Subject: Firmware Release Note: Main		Prepared by: Y. Miyamoto	
From: 1st Tech Service Sect., MFP/Printer Tech Service Dept.			
Classification:	☐ Troubleshooting ☐ Mechanical ☐ Paper path ☐ Product Safety	☐ Part information ☐ Electrical ☐ Transmit/receive ☒ Other (Firmware)	☐ Action required ☐ Service manual revision ☐ Retrofit information ☒ Tier 2

Model: RM-MF		Date: 20-Nov-14	No.: RM156003
Subject: ADF part change information		Prepared by: T. Sakakibara	
From: 3rd Tech Service Sect., MFP/P Tech Service Dept.			
Classification:	☐ Troubleshooting ☒ Part information ☐ Action required ☐ Mechanical ☐ Electrical ☐ Service manual revision ☐ Paper path ☐ Transmit/receive ☐ Retrofit information ☐ Product Safety ☐ Other () ☐ Tier 2

Model: Rmy-P1/MF1		Date: 21-Aug-15	No.: RM156005
Subject: Part Additional Description: HARNESS:ID-CHIP:SUB-ASS'Y			Prepared by: Takuma. Sakakibara
From: 2nd Tech Service Sect., MFP/Printer Tech Service Dept.			
Classification:	☐ Troubleshooting ☒ Part information ☐ Action required ☐ Mechanical ☐ Electrical ☐ Service manual revision ☐ Paper path ☐ Transmit/receive ☐ Retrofit information ☐ Product Safety ☐ Other () ☒ Tier 2

Subject: Caution regarding "Engine Me

Change:

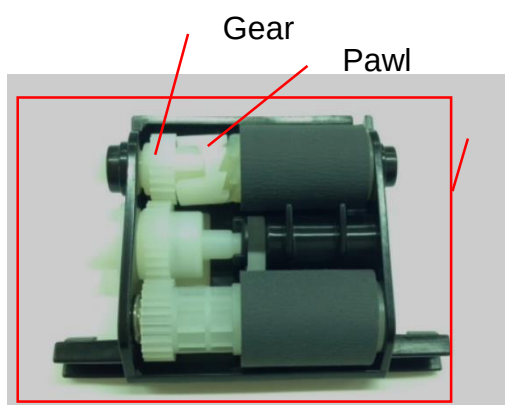
1. Material of the gear (M1562825) and the pawl (M2021773) used in the feed roller of the ADF feed unit were changed from nylon to POM (Polyoxymethylene).
2. Discharge brush (M2021779) was newly added.
3. PICKUP ROLLER:ASS'Y was newly available.

Above changes 1 and 2 were made to improve ADF no-feed problems in a low temperature and low humidity environment (LL environment: 10°C, 15% RH).

Both changes were made to neutralize static electricity.

Part changes were applied to mass production from July 2014.

Replace the entire PICKUP ROLLER:ASS'Y or ADF ASS'Y when its sub pieces are damaged.

Copier model SP mode

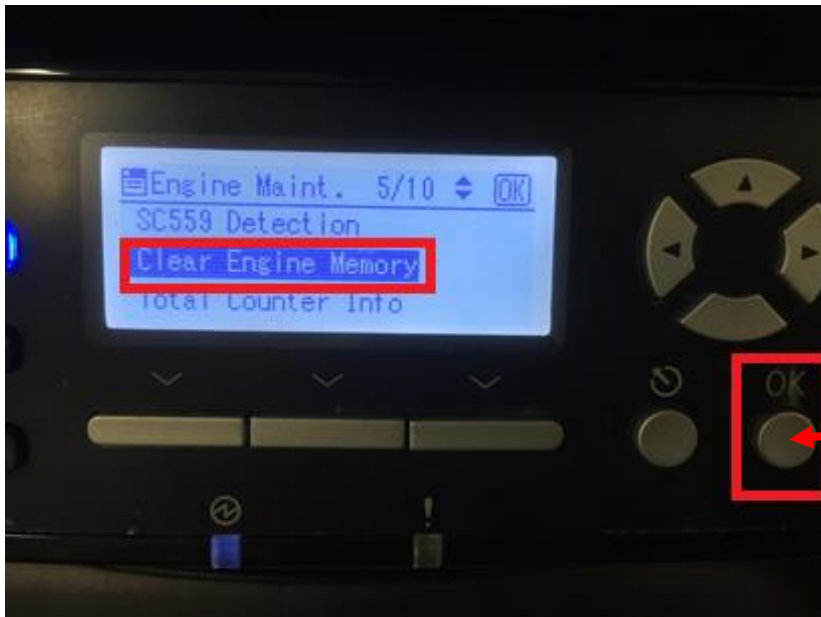
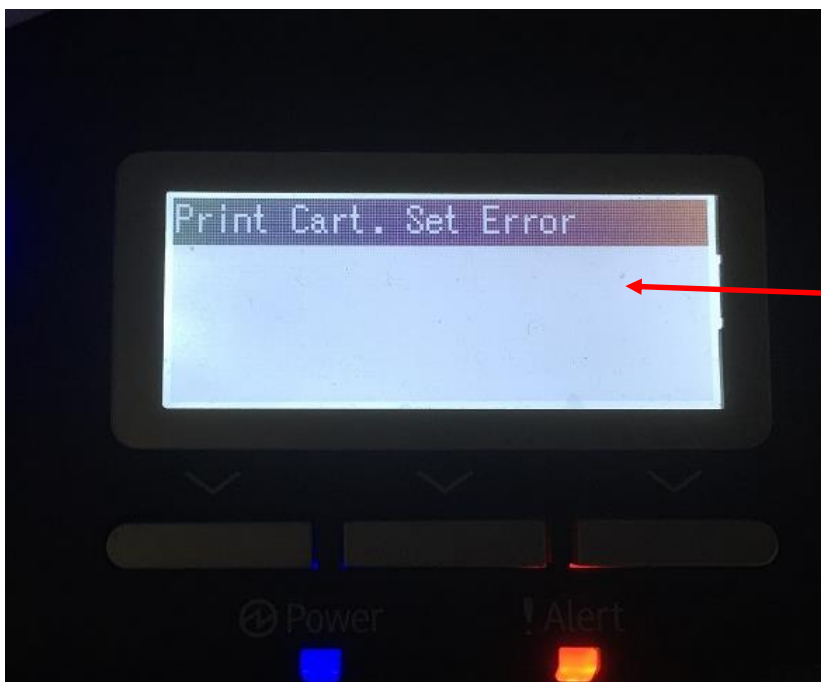
Clicking the "Clear Engine Memory" button in the SOM (printer configuration screen) or the SP mode will falsely reset all the engine related values stored in the main board, preventing the device from recognizing the AIO.

DO NOT click the "Clear Engine Memory" button.

DO NOT select [Clear Engine Memory] and click OK!

Device no longer detects AIO.

If the Clear Engine Memory button had been pressed, update the Main firmware to "ver.1.04" or later to resolve the situation.

Copier model SP mode

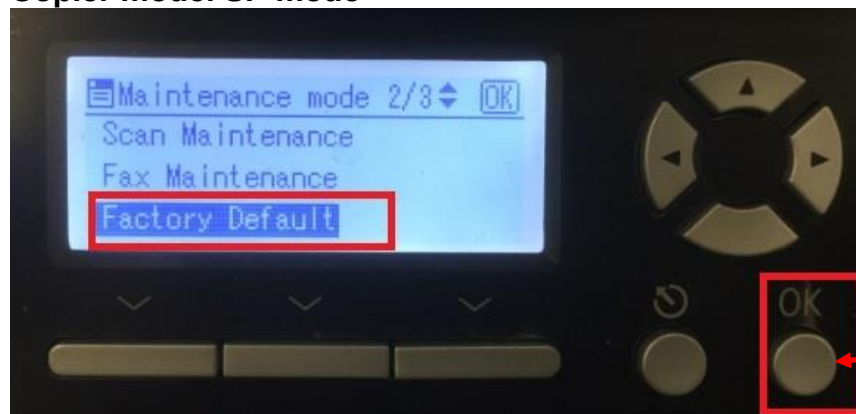
Select [Factory Default] and click OK.

Model Rmy-MF1 (TypeG)

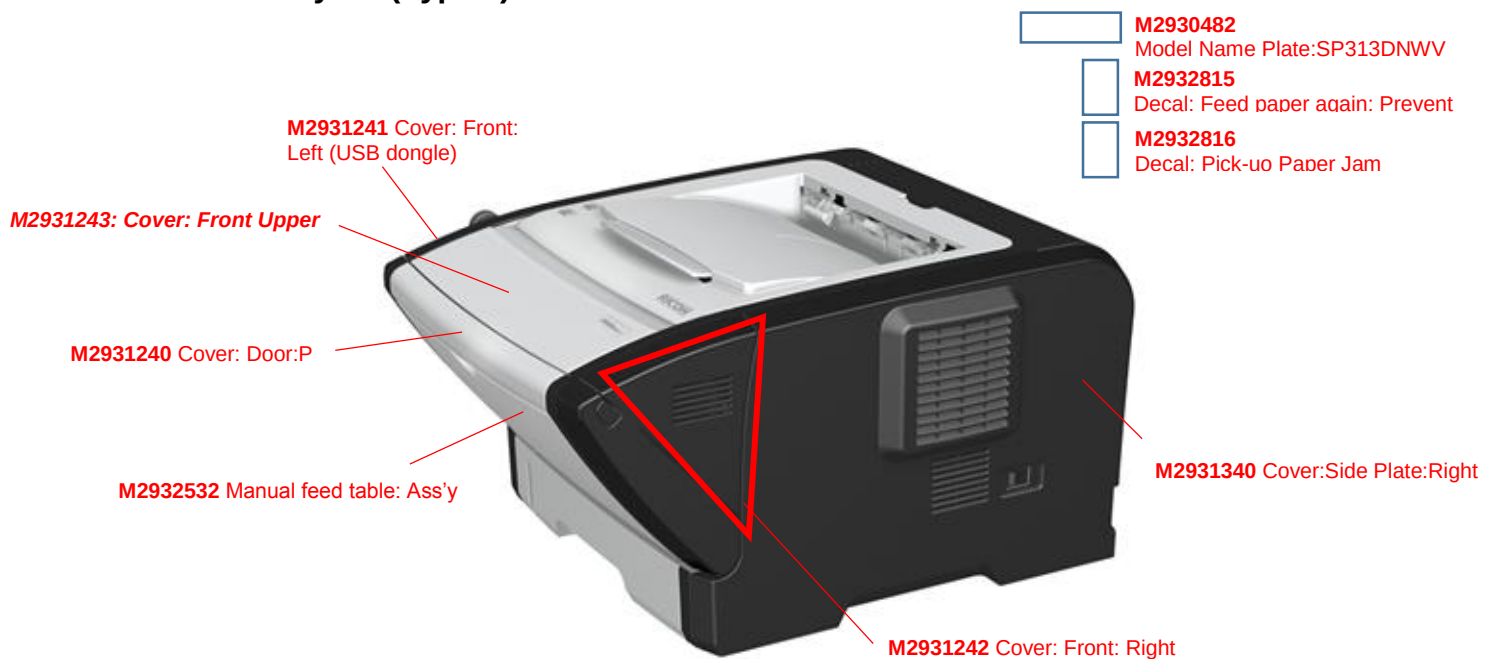
New parts are added as follows.
